DEPARTMENT OF WATER RESOURCES

January 30, 2009

Figure 1.

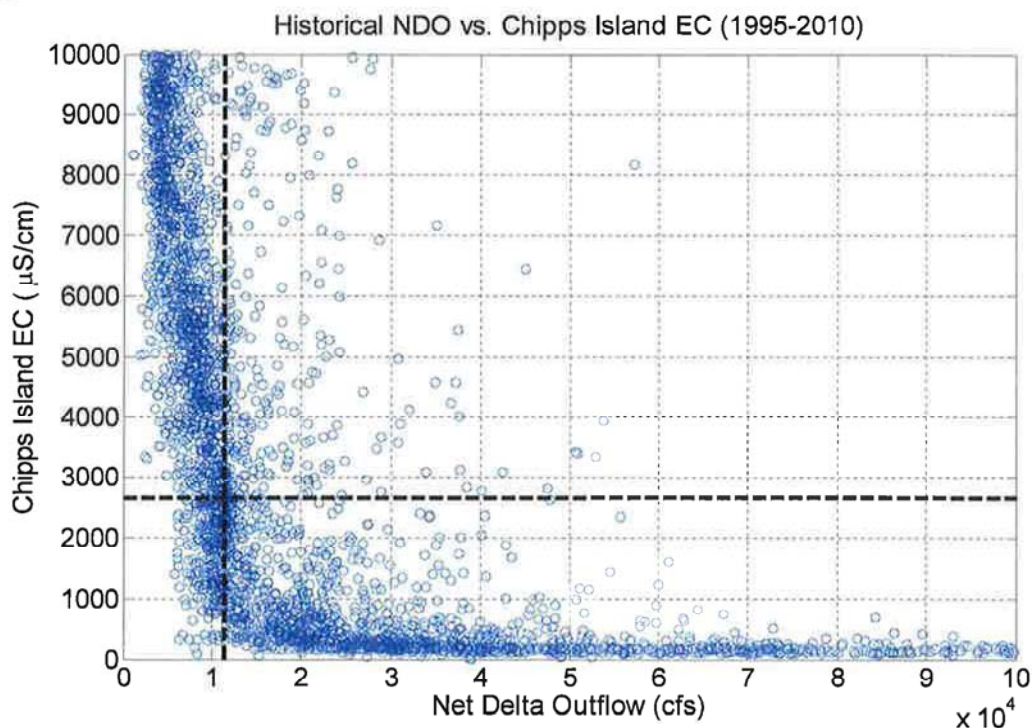
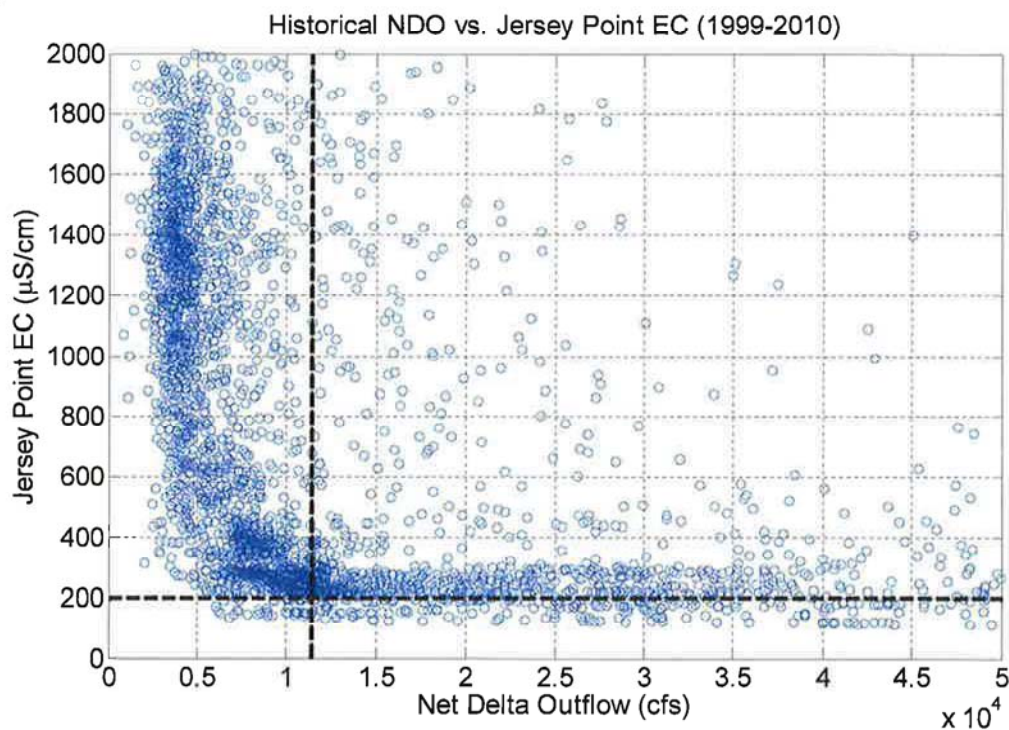
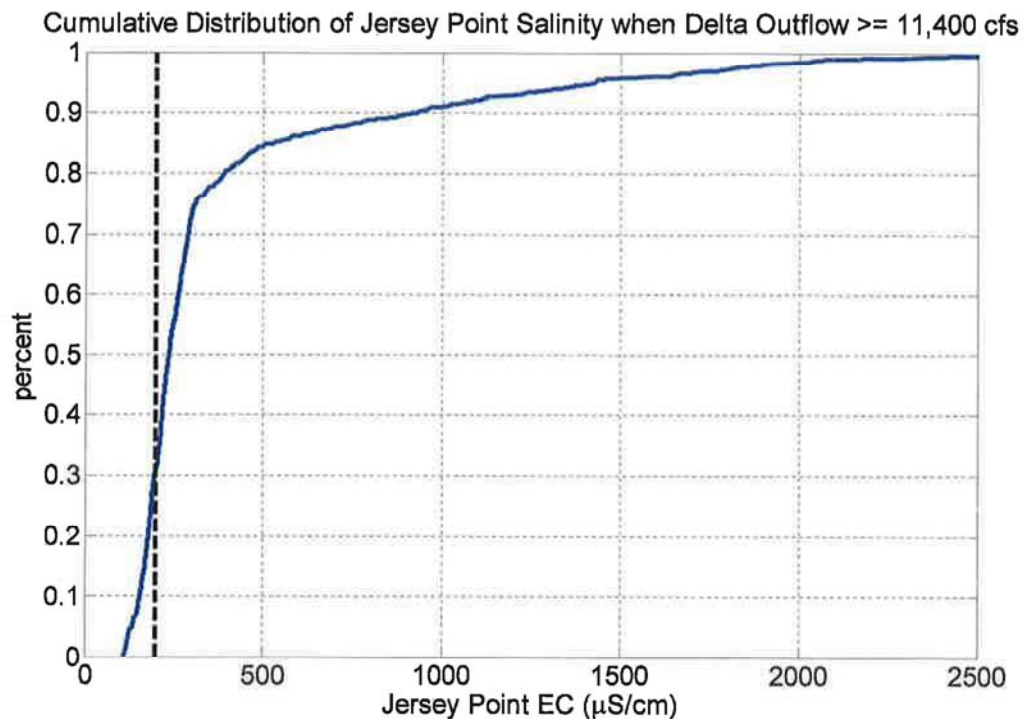
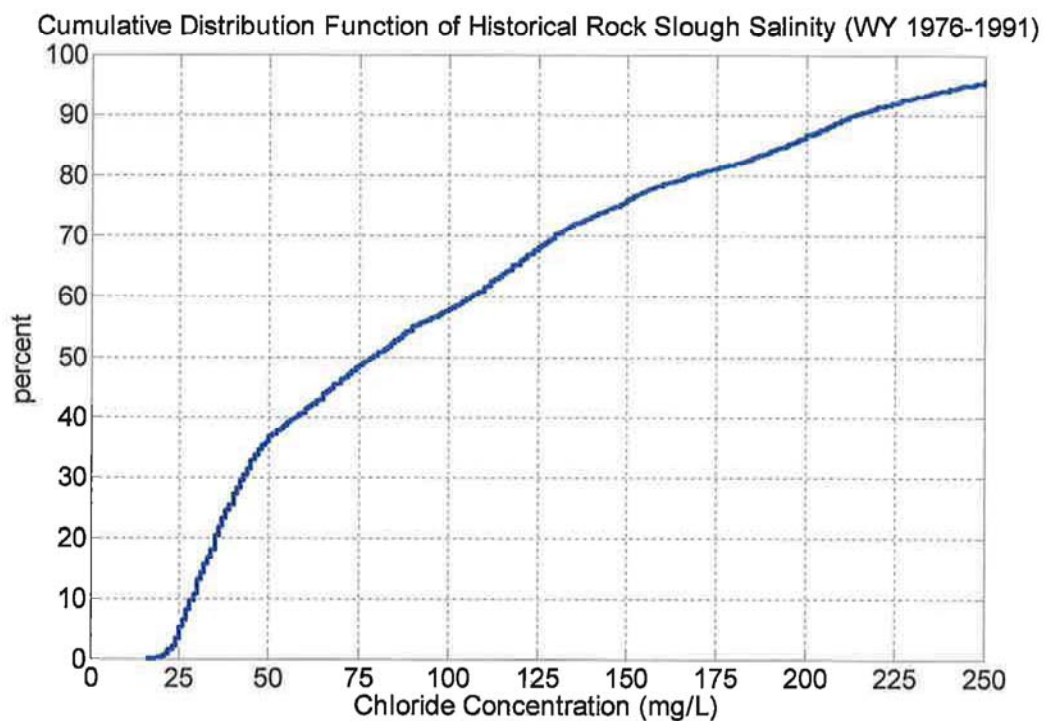
- On page 4.2-36, the DEIR includes the assumption that a Delta outflow of 11,400 cfs is equivalent to X2 (the 2 parts per thousand isohaline) being at Chipps Island (75 km from the Golden Gate). While this outflow is one of the 1994 Bay-Delta Accord/D1641 “three ways to comply” with the X2 standards specified for the state and federal export projects, the DWP operational restrictions do not specify the same three ways to comply, and it is not always true that salinity at Chipps Island is below 2,640 uS/cm EC when outflow is 11,400 cfs or more. (See Figure 1.) X2 can be related to Delta outflow (for instance, using the well-established Kimmerer-Monismith equation), but antecedent outflow must also be included to yield accurate results. Terms 3a(1) and 3a(2) of the CCWD PDA require DWP diversions to be limited based on the actual position of X2 rather than an equivalent outflow.

- On page 4.2-30, the DEIR states that Jersey Point EC is “likely” to be less than 200 uS/cm when outflow is greater than 11,400 cfs. Field data collected over the past 10 years shows that this is the case less than a third of the time, and Jersey Point EC can be an order of magnitude greater even at twice the outflow. (See Figure 2.) Analysis of potential impacts of DWP diversions on Delta water quality standards at Jersey Point based on this assumption would yield misleading conclusions.

- Calculated chloride concentrations at Rock Slough Intake are unrealistically low. As presented in Table 4.2-6 (which is mislabeled in the body of the table as “Jersey Point EC”), the median value for half the year is less than 20 mg/L. In reality, chlorides at Rock Slough are very rarely that low; historical records from 1976-1991 show that Rock Slough chlorides are less than 20 mg/L less than 5% of the time. (See Figure 3.) Term 3c of the CCWD PDA restricts DWP diversions from causing an increase of more than 10 mg/L chloride at any CCWD intake; it is difficult to verify that this condition is being met, since the DEIR water quality model is miscalibrated.

improved if it were to incorporate a more realistic relationship between Delta outflow and salinity. The G-Model is one of the simpler commonly used models employed to estimate Delta salinity which accounts for antecedent conditions.

Attachment – 1st Bullet: Comment noted. The Protest Dismissal Agreement includes diversion restrictions under Term 3.a that are based on actual position of X2 rather than equivalent flow. Daily Project operations will comply with the requirements of Term 3.a to address CCWD water quality concerns. The Draft Environmental Impact Report (DEIR) used equivalent flows and the Kimmerer-Monismith equation as a methodology to estimate changes in X2 associated with Project operations.

Attachment – 2nd Bullet: The strong relationship between Delta outflow and Jersey Point salinity support the modeling assumptions included in the In-Delta Storage Model (IDSM) and the conclusions presented in the DEIR. As evidenced by Figure 4.2-7c of the DEIR and Figure 2.a of CCWD's comment letter, Jersey Point electrical conductivity (EC) is very low at Delta outflows in excess of 11,400 cfs. In addition, Project diversions would occur only in the months of December to March when there are no established salinity objectives for Jersey Point.

Attachment – 3rd Bullet: Comment noted. Table 4.2-6 was mislabeled. The Rock Slough chloride concentrations in the DEIR were estimated in the IDSM utilizing the CCWD G-model equation. Salinity changes were minor and never approached the 10 mg/L constraint included in Term 3.c of the protest dismissal agreement. Daily Project operations will fully comply the requirements of Term 3.c to address CCWD water quality concerns.

Attachment – 4th Bullet: Comment noted. The improvements in Rock Slough chloride concentrations described on page 3-27 oversimplified the relationship between outflow and Rock Slough salinity. The analysis in Chapter 4.2 did incorporate the CCWD G-model equation, including antecedent flow conditions and effective Delta outflow. The changes in Rock Slough chloride concentrations are presented in Table 4.2-6.
